July 27, 1981

The enclosed paper will be presented and submitted for record at the July 29, 1981 public hearings on the San Onofre Nuclear Generating Station licensing of units two and three to be held at San Clemente High School.

THE VULNERABILITY OF  
THE SAN ONOFRE NUCLEAR GENERATING STATION TO ACTS OF  
SABOTAGE AND TERRORISM

Fig. 1. Unit 1 intake terminal structure.

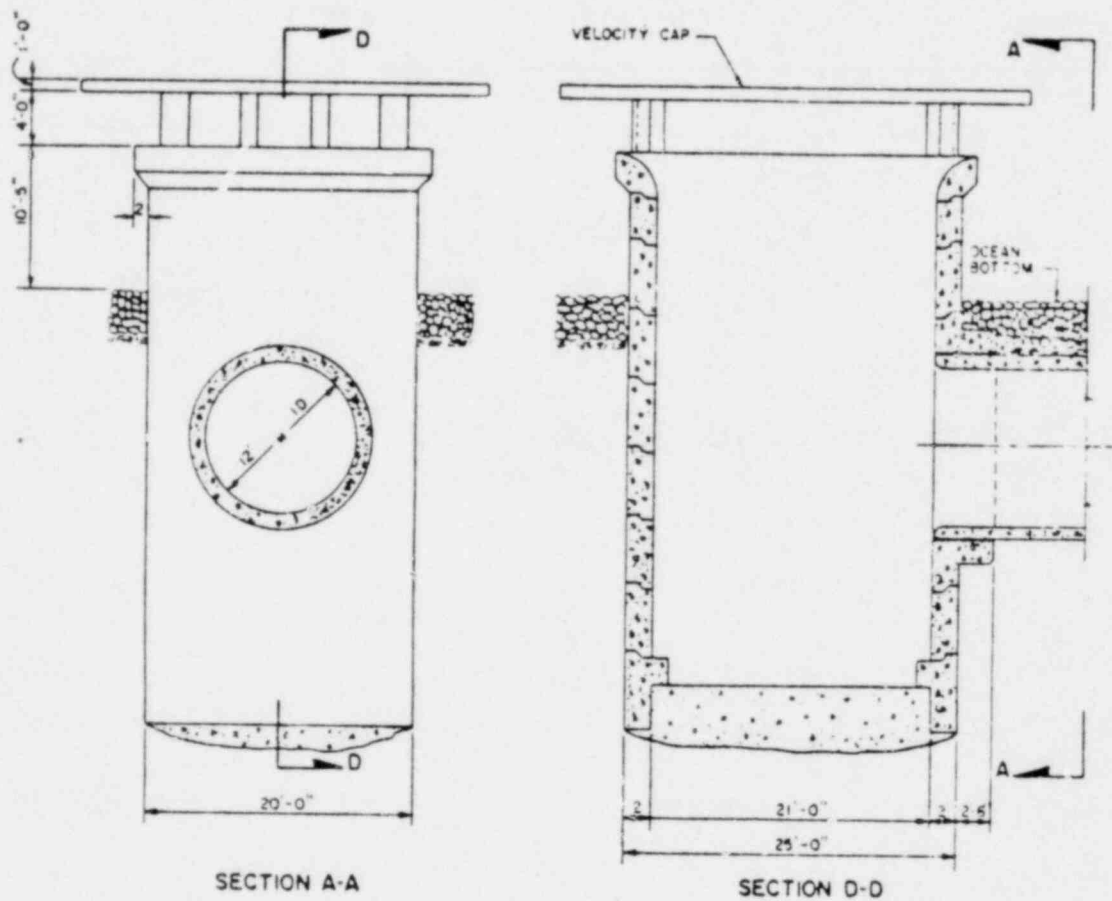
This study of sabotage and terrorism was primarily focused on the ocean cooling system. There are no security systems protecting the entrance of the ocean intake structures of all three reactors and all three are extremely vulnerable to irreparable destruction by way of knocking out the systems that provide critical cooling ocean water to the main steam condensers, the component circulating water heat exchangers, and the turbine plant circulating water heat exchangers. "Critical" in that without the millions of gallons of water per minute that are pumped through these condensers ~~and~~ a core meltdown would be eminent.

An example of this vulnerability is that a scuba diver can easily swim into the intake structures (fig.1) and 3300 feet through the large pipes (fig.2) and be inside the plant in about eight minutes

place explosives near the pump impellers. Then with the help of a boat and line be pulled out and after some miles away detonate the explosives stopping all cooling waters to the condensers, creating within hours a core meltdown.
